Contract Change Order # 1

Project Name: <u>East Nashville Street</u>	Project Number: <u>ED1701</u>
Project Location: <u>E. Nashville on Lynn Lane between 81st and 91st</u>	Date of Application: <u>Tuesday, February 12, 2019</u>
Contractor: <u>Crossland Heavy Contractors</u>	Submitted By: <u>Chris Walters</u>

Summary of Change in Scope of Work

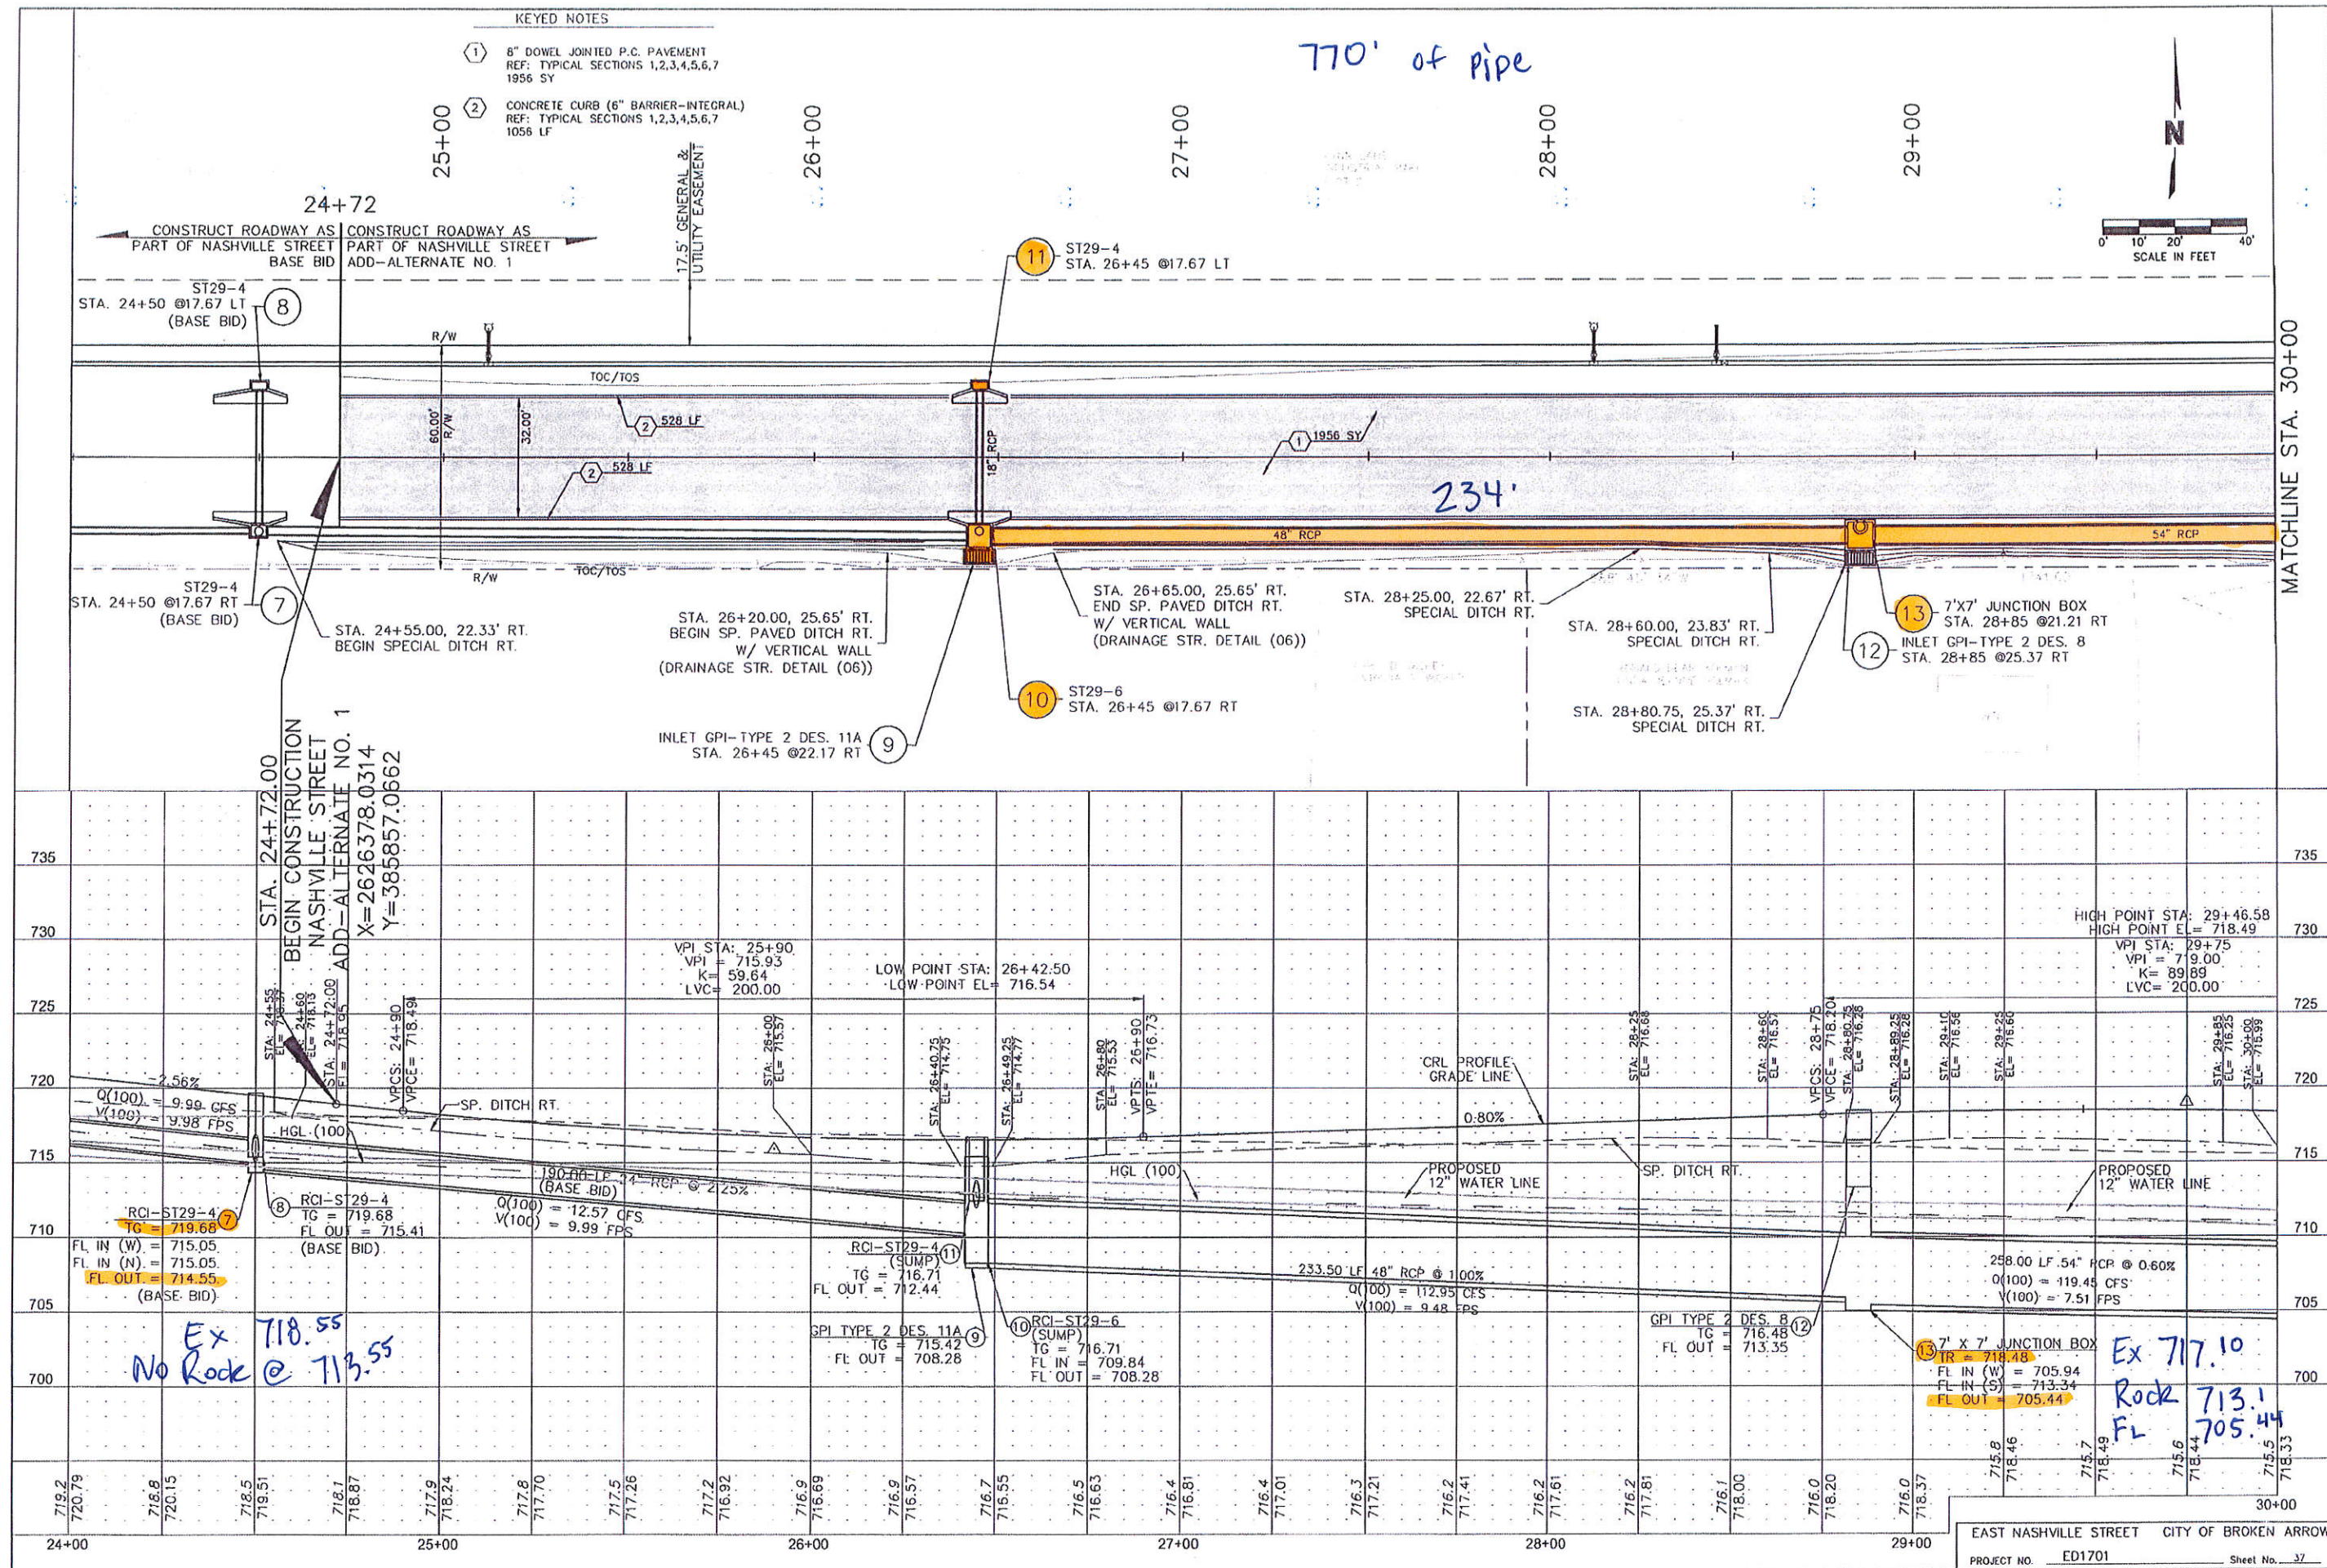
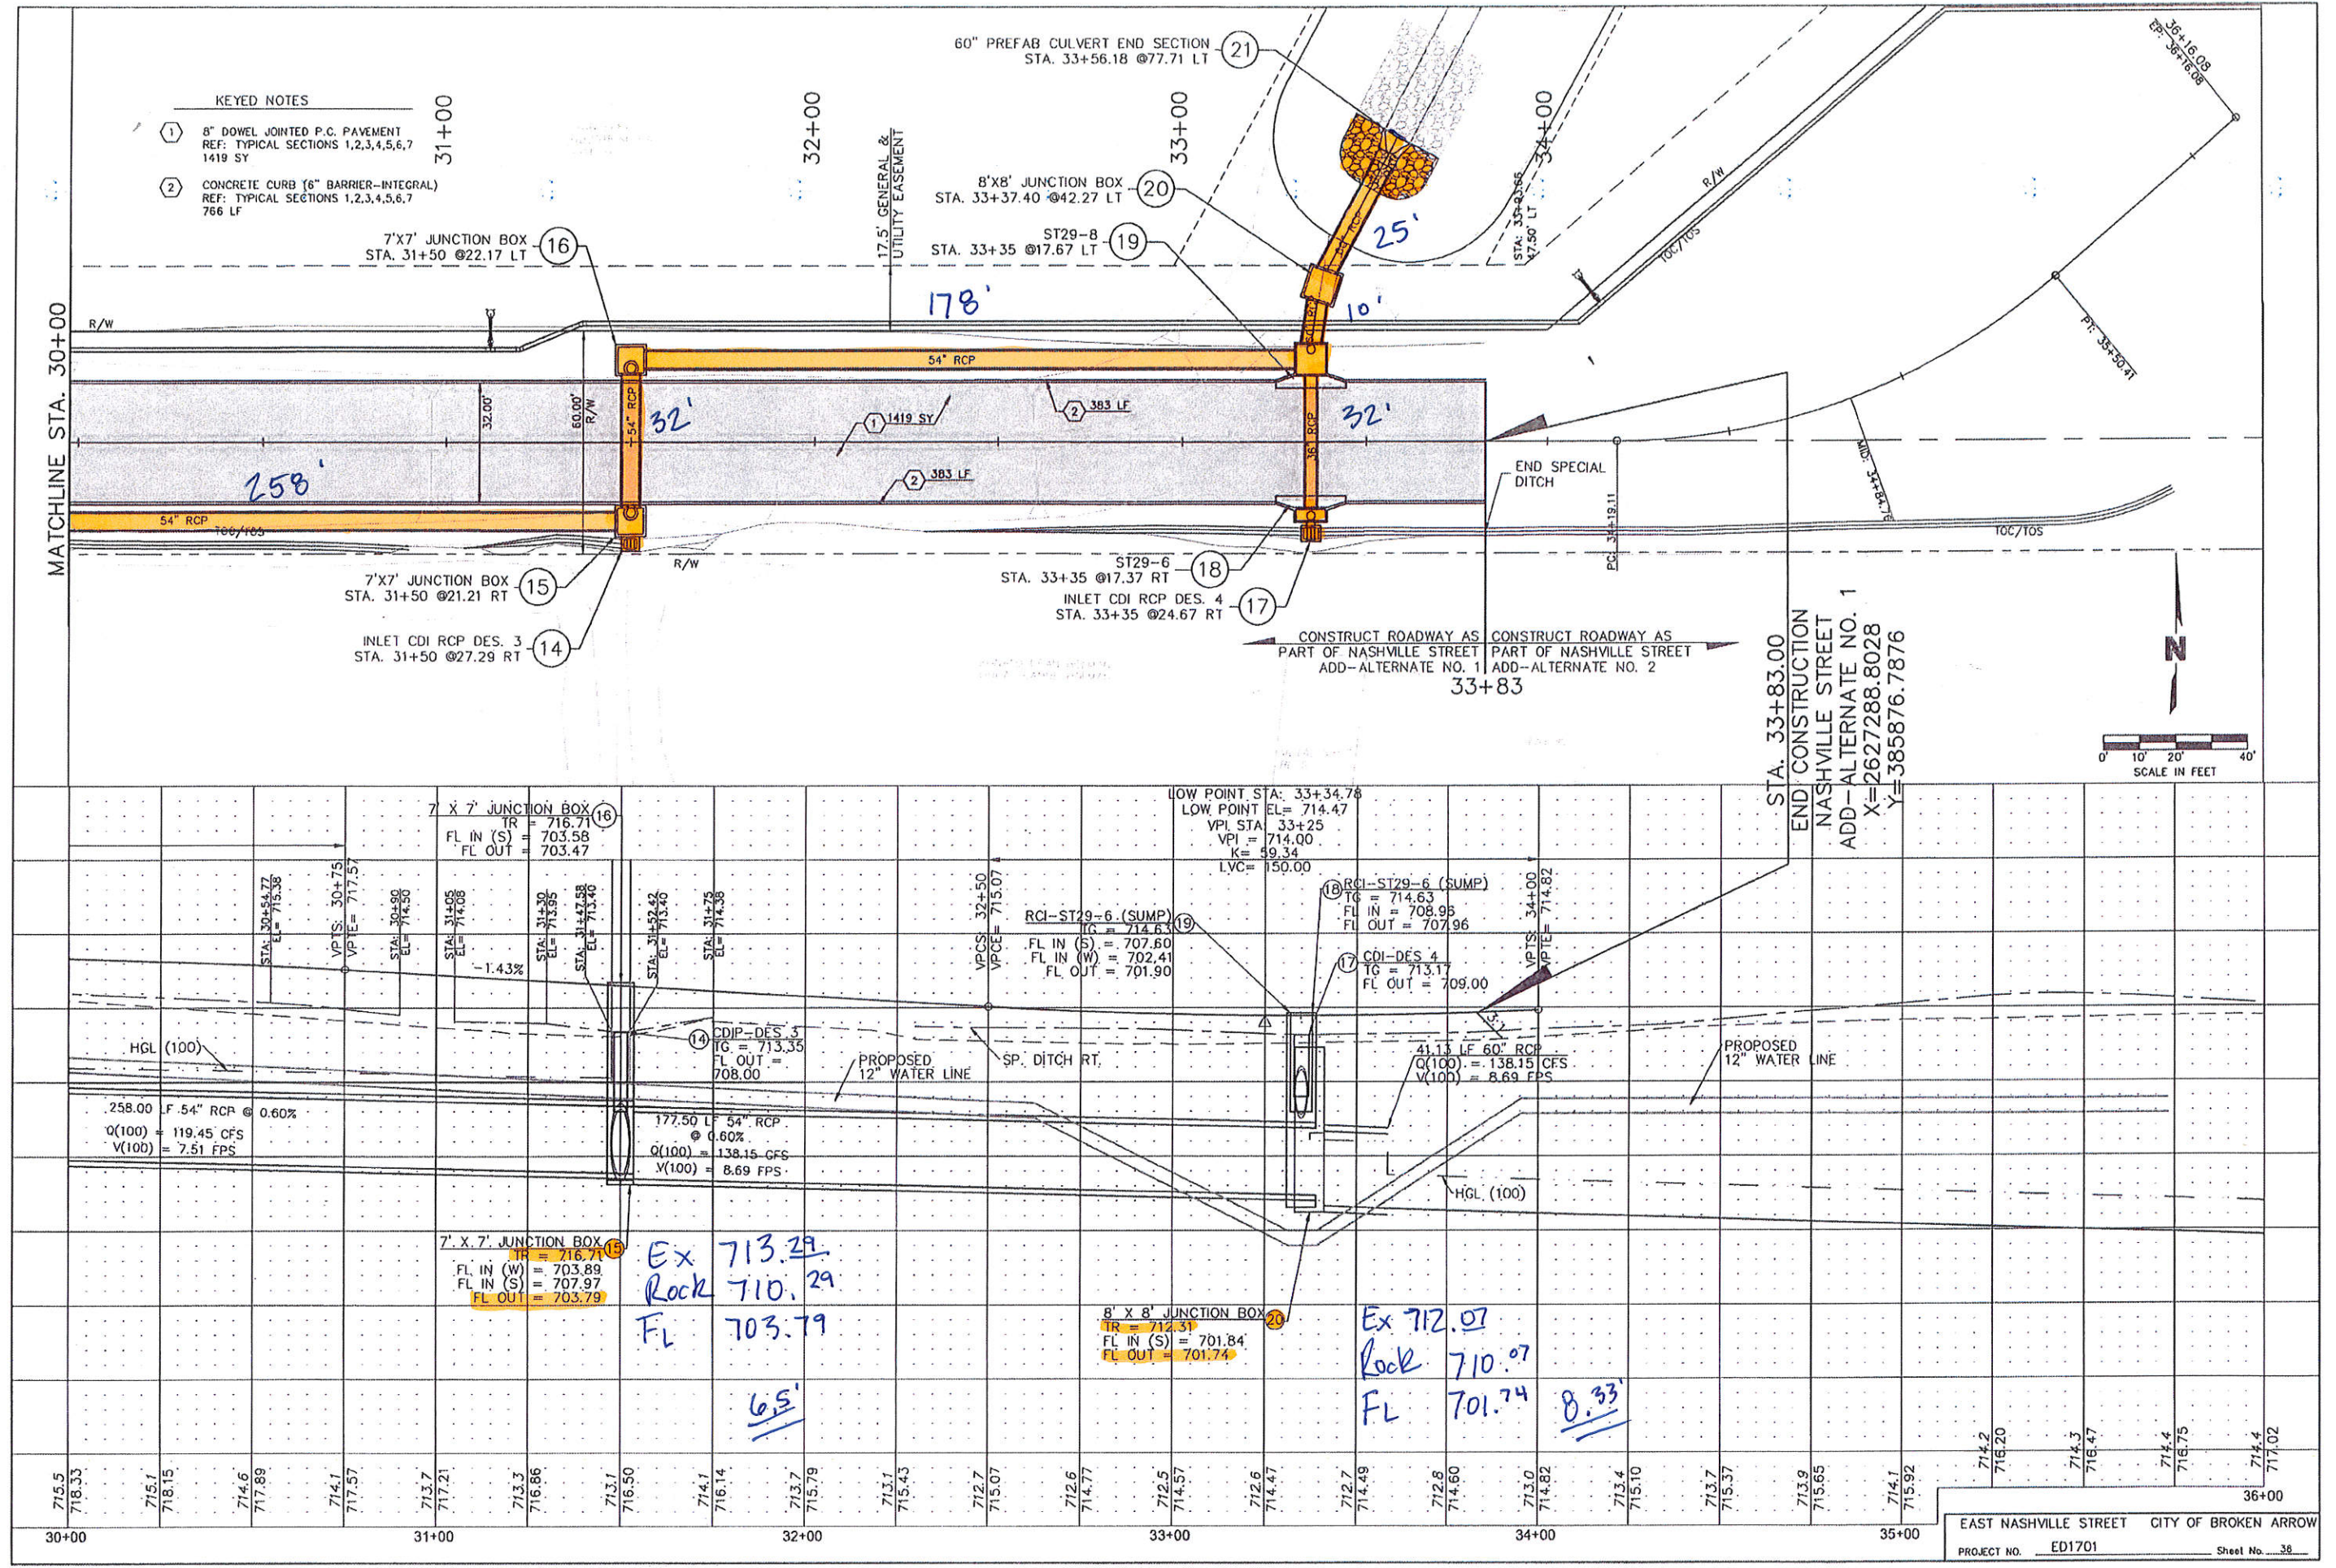
This letter is to address the additional costs associated with rock encountered during excavation of the storm sewer. Per the Geotechnical Engineering Report prepared by Olsson Associates, seven bores were taken to a depth of 5'-0. The report claims that in this 5'-0, samples of the soil taken consisted of sandy lean clay with various amounts of sand, fat clay, silty clay, and silt. Nowhere in the report does it claim rock was encountered.

I've attached a plan sheet showing where rock was encountered in orange. It also shows existing elevations, elevations that rock was encountered and flowline elevations.
